Access Compliance Report

Public Rights-of-Way

(Curb Ramps)

Intersection ID: 25709	Main Street: CHARTER_OAK_LN	Cross Street: JOHNSTON_RD	Location: SW
ADA ID: 29FDAB5DFB3E	Ramp Type: Perp	Initial Pass/Fail: Fail	Overall Compliance: No
Severity Score: 12.5			
Codes/Mitigation Info/Possible Solution		Field Measurements/Component Compliance

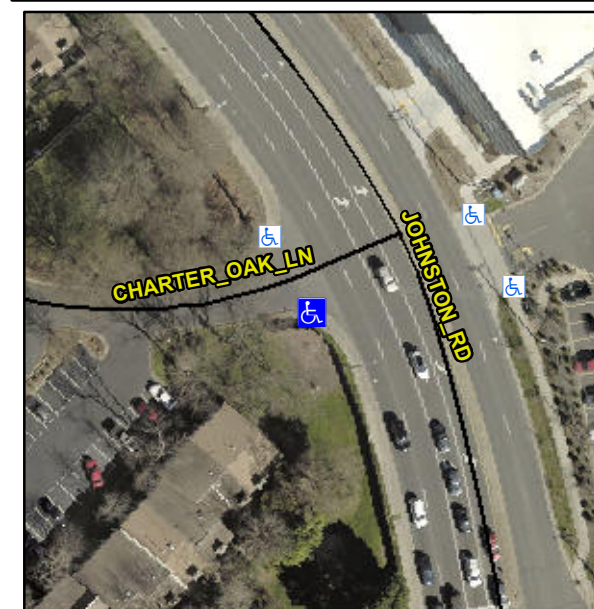
Not Found, R304.5.3

Compliance	Description	Data	Compliance	Description	Data
N/A	Ramp Length (in)	63.0	Yes	Ramp Slope (%)	5.2
Yes	Ramp Width (in)	48.0	No	Ramp XSlope (%)	6.5
N/A	Flare Type LT	N/A	N/A	Flare Type RT	N/A
N/A	Flare Slope LT (%)	N/A	N/A	Flare Slope RT (%)	N/A
N/A	Flare Traversable LT?	N/A	N/A	Flare Traversable RT?	N/A
N/A	Landing Length (in)	N/A	N/A	DWS Provided?	N/A
N/A	Landing Width (in)	N/A	N/A	DWS Contrast?	N/A
N/A	Landing Slope (%)	N/A	N/A	DWS Length (in)	N/A
N/A	Landing X Slope (%)	N/A	N/A	DWS Full Width?	N/A
N/A	Landing Curb? (Y/N)	N/A	N/A	DWS Offset (in)	N/A
N/A	Shared Landing?	N/A			
N/A	Gutter Ponding?	N/A	N/A	Gutter Slope (%)	N/A
N/A	Gutter Lip Ht (in)	N/A	N/A	Gutter X Slope (%)	N/A
N/A	Painted X Walk1?	No	N/A	Painted X Walk2?	N/A
	X Walk 1 Direction	To NW		X Walk 2 Direction	N/A
N/A	X Walk 1 Width (in)	N/A	N/A	X Walk 2 Width (in)	N/A
	X Walk 1 Slope (%)	0.1		X Walk 2 Slope (%)	N/A
	X Walk 1 X Slope (%)	5.5		X Walk 2 X Slope (%)	N/A

Remove & Replace Entire Ramp.
